Sams Fashion (10011)

Sams Socks

Keowa Pashim Khanda (Koroitola), Mawna, Sreepur, Gazipur

02.JUNE.2014

- Inconsistencies between the drawings and the actual as-built conditions of Building 1

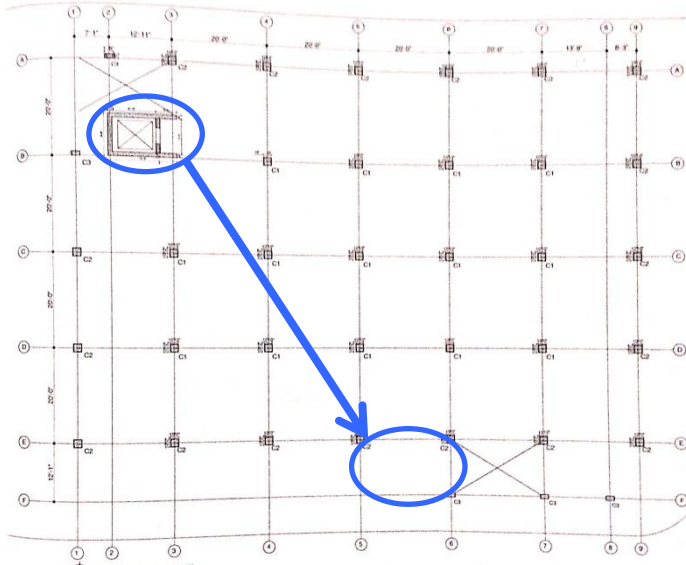
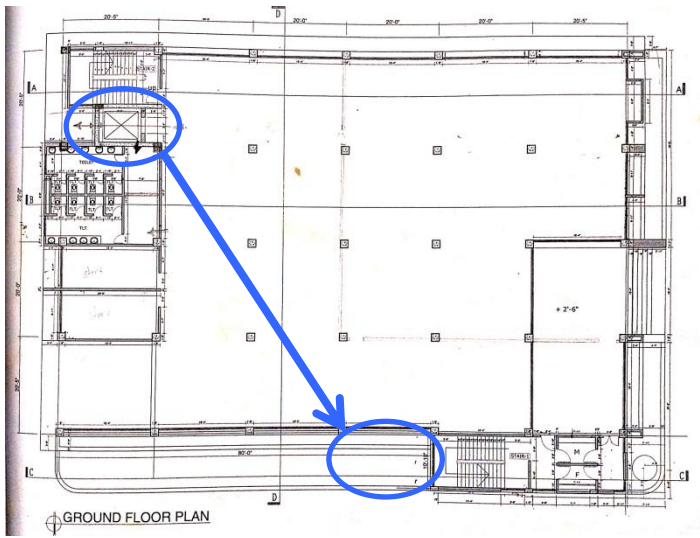
We were informed that the shear wall will be constructed between grid line E-F/5-6 instead of grid line A'-B/2-3.
